### **ADDENDUM #4**

#### **TO THE CONTRACT DOCUMENTS FOR THE CITY OF PALM BAY**

IFB # 39-0-2020/JG, South Regional Water Reclamation Facility Construction

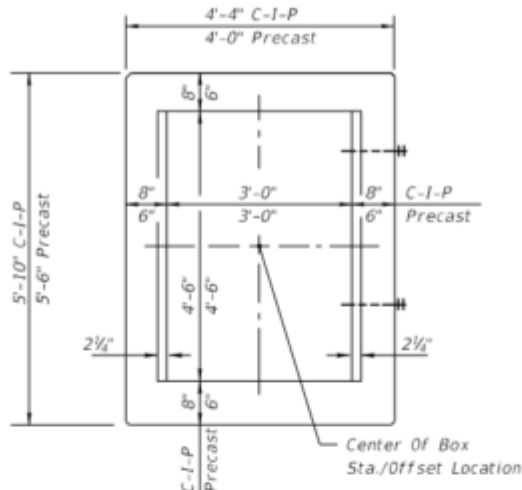
**Q3. Drawings C-7 and C-8 show what appear to be bollards as dark filled circles at the ends of roads A, B, C, and E. The only drawing that specifically notes that any of these dark filled circles are bollards is Drawing C-20 at the end of road B, and it says “See detail on Process Sheets”. The Process Sheets do not have a detail for bollards. Drawing C-7, as well as Drawings C-10, C-14, C-16, C-23, and C-30, show smaller, non-filled circles along road D near a proposed Fire Hydrant. The Fire Hydrant detail on Drawing C-35 does not show bollards. Drawing P-15 also shows seven bollards at the Sludge Transfer Pump Station that are not shown on any of the C drawings. Drawing P-17 calls out the bollards at the Sludge Transfer Pump Station as 8”.**

- A. Are the smaller, non-filled circles near the fire hydrant to be bollards?**
- B. Could you please provide a detail for the required bollards?**
- C. Could you please clearly indicate the size for each required bollard?**

A3. A. The non-filled circles are bollards.

B. See detail on S-25.

C. All bollards will be consistent in size matching the bollard on S-25.

Revise Sheets C-7 & C-8 by labeling the dark filled circles as bollards. Revise Sheet C-20 from “See detail on Process Sheets” to “See bollard detail on Sheet S-25”. Revise Sheets C-10, C-14, C-16, C-23, and C-30 to label smaller non-filled circles as bollards. Revise P-17 by deleting the size of the bollards.

TYPE E

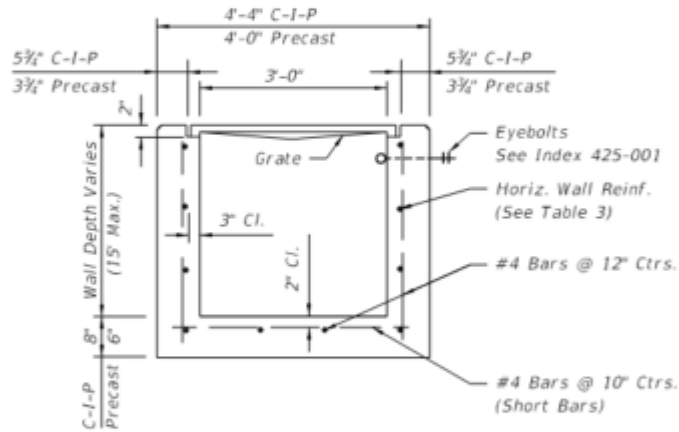
**Q4. On Drawing C-11, STM CB 1 is shown as a Type E Inlet. Drawing C-32 only has details for Type C and Type D Inlets and Grates. Please clarify whether STM CB 1 is to be a Type E Inlet as shown on Drawing C-11 and, if so, please provide details for the required Type E Inlets and Grates.**

A4. STM CB 1 was correctly called out as a Type E Inlet to provide the sufficient weight loading capacity. Please refer to FDOT FY 2018-2019 Standard Plans Index 425-052 Sheet 1 of 7 for reference to Type E Inlets.

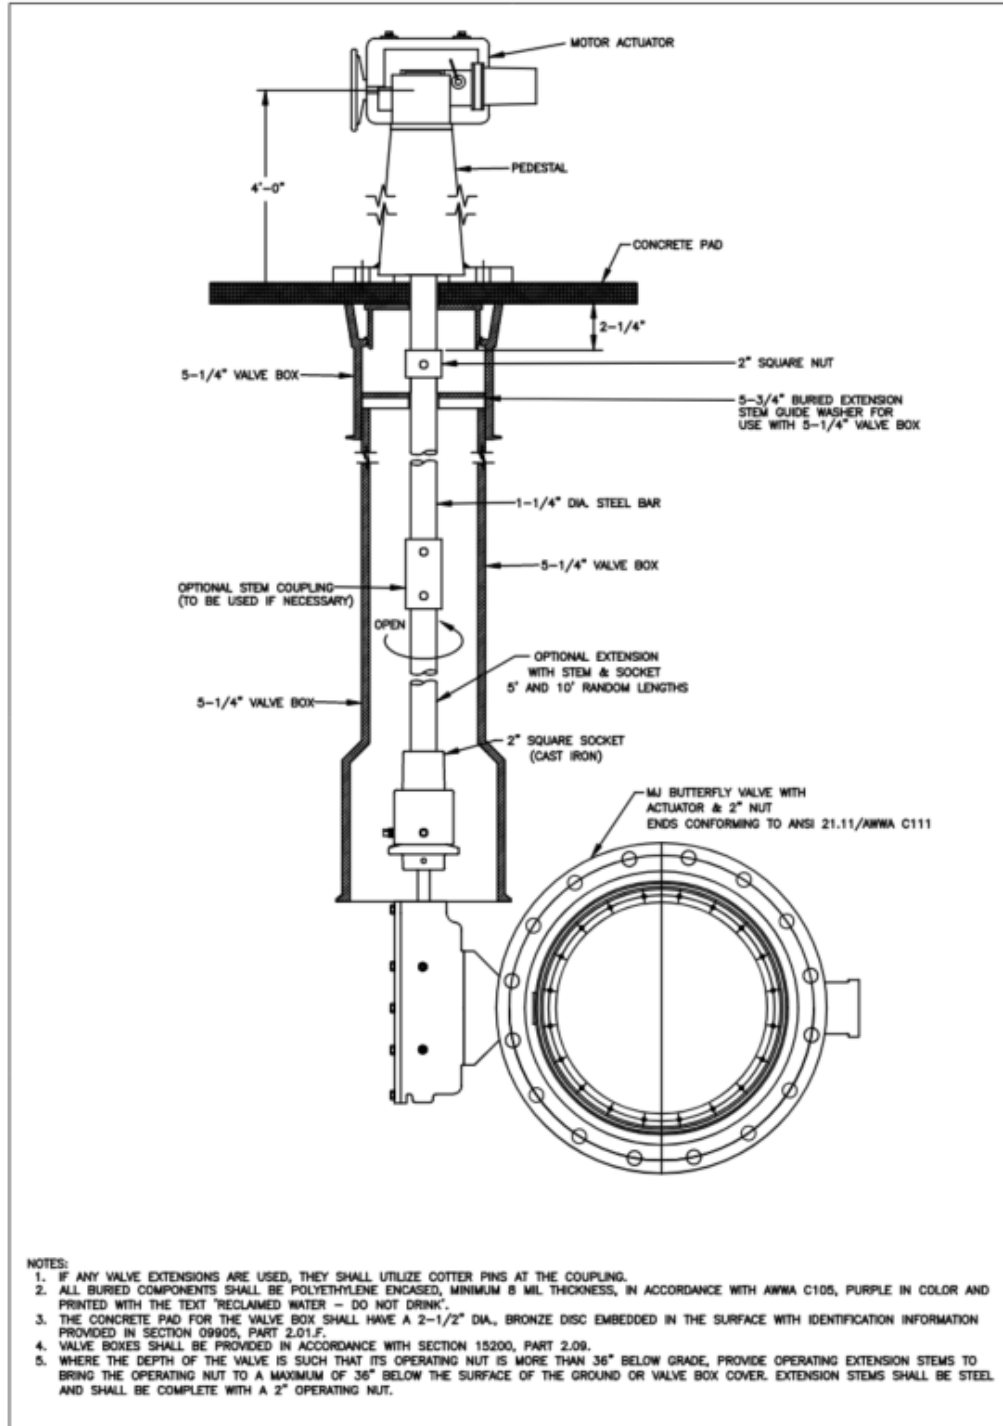
**Q8. Drawing C-29 does not indicate the distance between the proposed 24" line to the Injection Well and the existing 16" line and there is no way to estimate the distance from the information shown. For bidding purposes, please provide an estimated distance between the tees shown in the Injection Well Bypass detail on Drawing C-29 so that all bidders are pricing the same work.**

A8. Assume 75 feet. The 16" line runs directly west from the valve pad that is visible above grade. Location of 16" line shown in blue below.

Add Note 3 to Sheet C-29:

"3. Field locate connection point. For bid purposes assume the length of pipe between the proposed 24" line to the Injection Well and the existing 16" line to be 75 feet."
